# Maine Yankee

Subject: Area Classification Change: Storm Drains (D3500) - Section 7

Attachment: LTP Rev. 3 Addenda dated January 26, 2005 – Attach 5A, pgs. 6 & 8 of 10

DRAWING NUMBER **FIGURE 1**

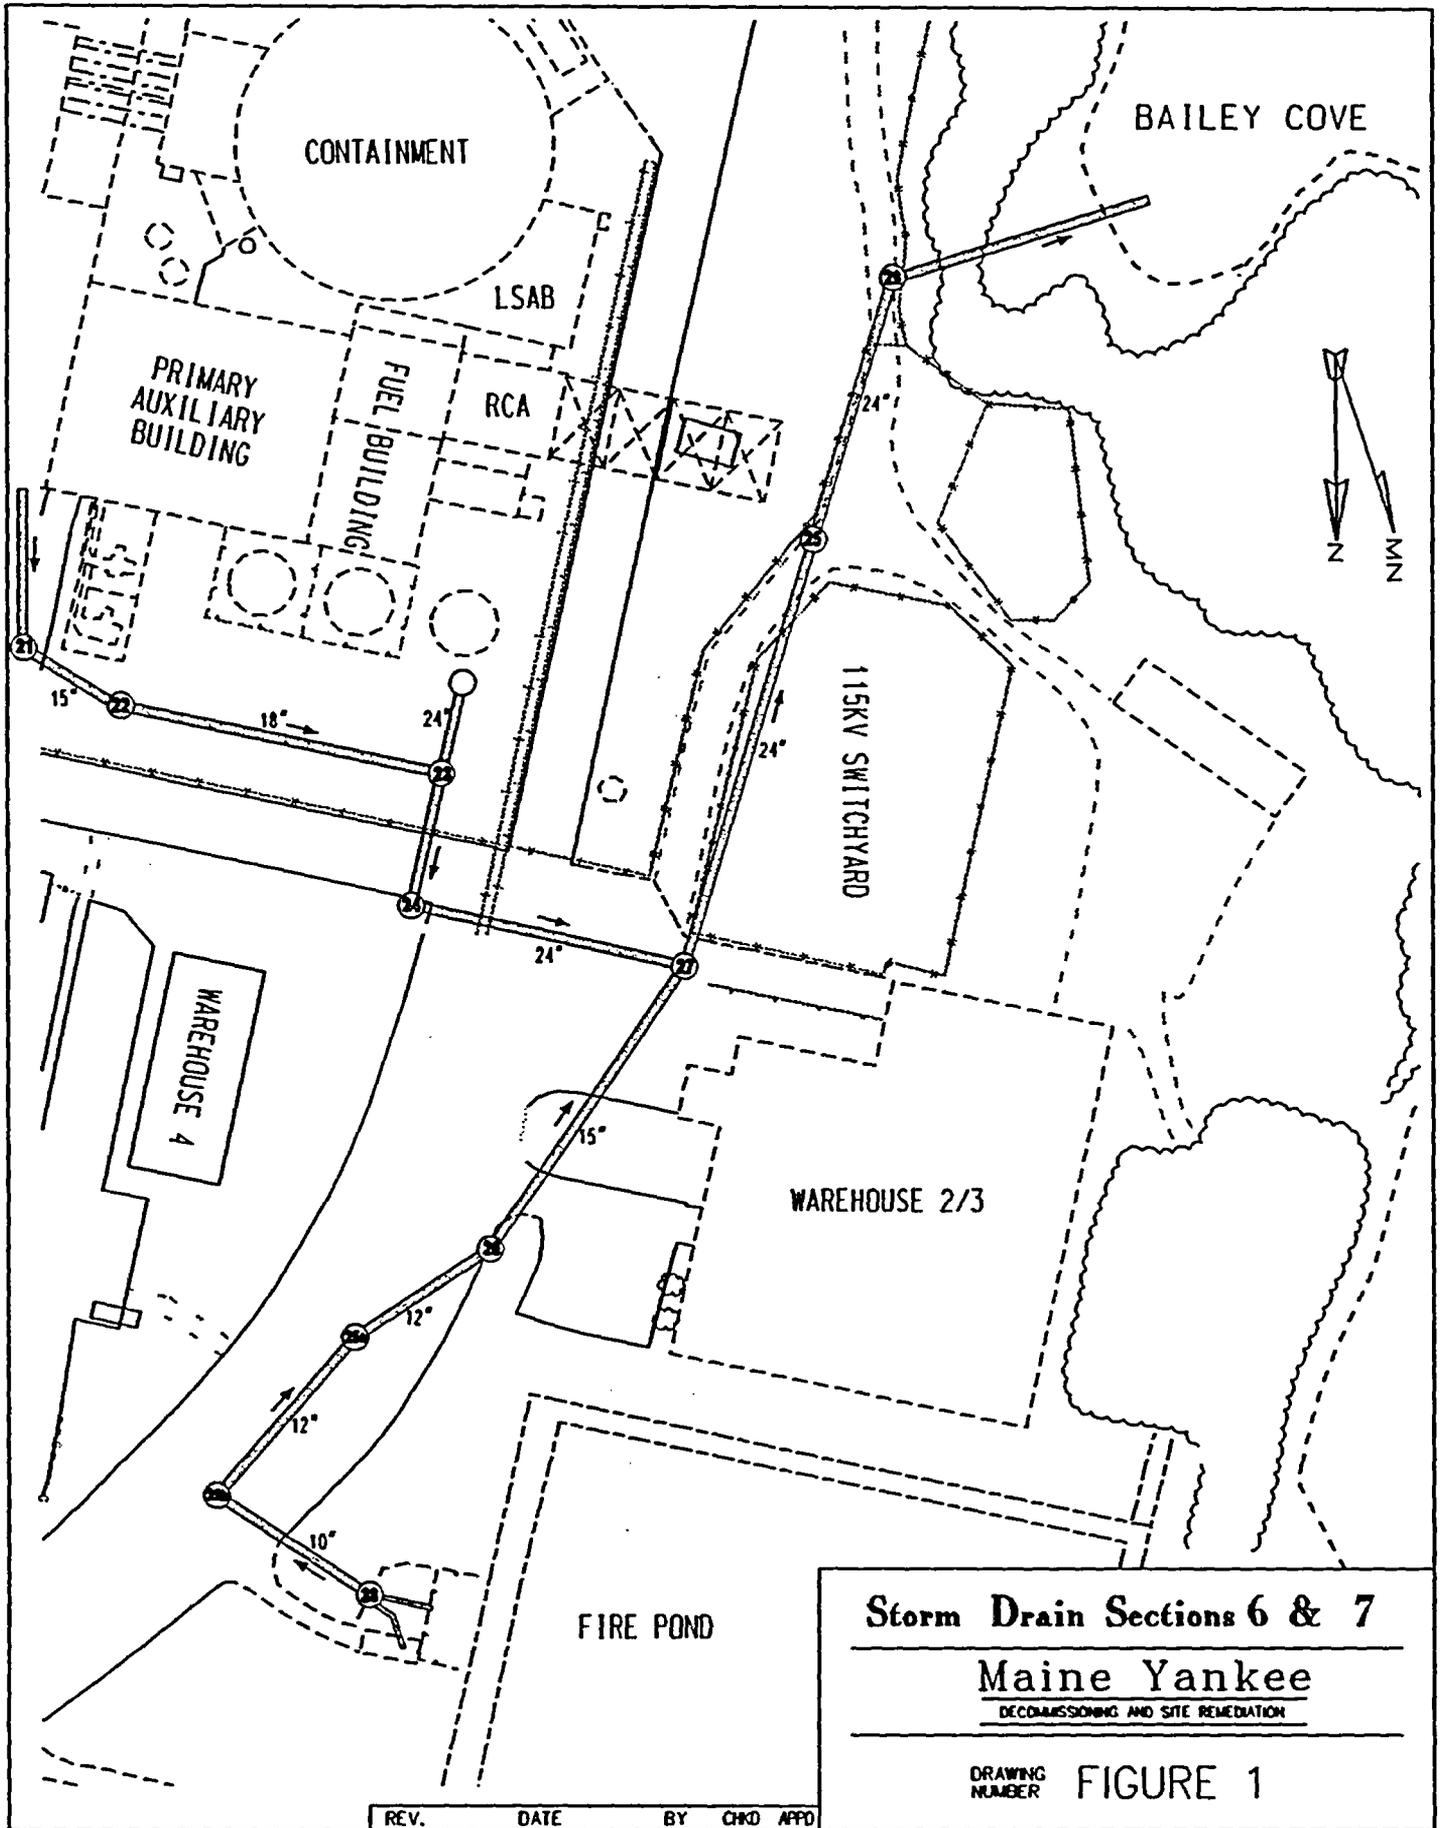
Section 7 of the Storm Drain System includes manholes 25A, 25B, 38 and 26 to 29. These manholes and connected piping drained the land surrounding the Fire Pond (including the overboard drain for the Fire Pumps), the land around the Warehouse, and the land outside the west boundary of the Restricted Area (RA). This land had been previously surveyed under the FSS program and was found to meet the criteria of Class 3 land. Water entering section 7 was clean (either fire pond water from Montsweag Brook or storm water runoff from the surrounding land and road surfaces). Only the portion of section 7 from the Fire Pond up to, but not including manhole 27 is being reclassified as Class 3.

This section was conservatively classified as Class 1 because it joined a portion of the storm drain system at manhole 27 that did drain the north portion of the RA. Manhole 27 is on the down stream portion of section 7 so any minor activity contained in the down stream section would be diluted by clean water coming from section 7. Both section 7 and the section connected at manhole 27 drained to Bailey Cove via outfall 006. Outfall 006 has been routinely monitored and the discharged water has typically been found to be less than MDA values with sporadic positive counts just above the MDA values. MDA's were maintained at approximately environmental LLD's associated with the Radiological Environmental Monitoring Program (REMP).

Based upon the foregoing information, Maine Yankee believes that a reclassification of storm drain section 7 upstream of manhole 27 satisfies the applicable criteria of the License Termination Plan.

Survey Unit: The Class 1 survey unit for the Storm Drain piping consists of the section of the piping bound by Manholes 30A and 31 through 37 and the section of the piping bound by Manholes 21 through 24, ~~25A, 25B, 26~~ through ~~29~~ and 38. The survey unit includes an unnumbered manhole adjacent to the location of tank TK-16 in the Restricted Area yard.
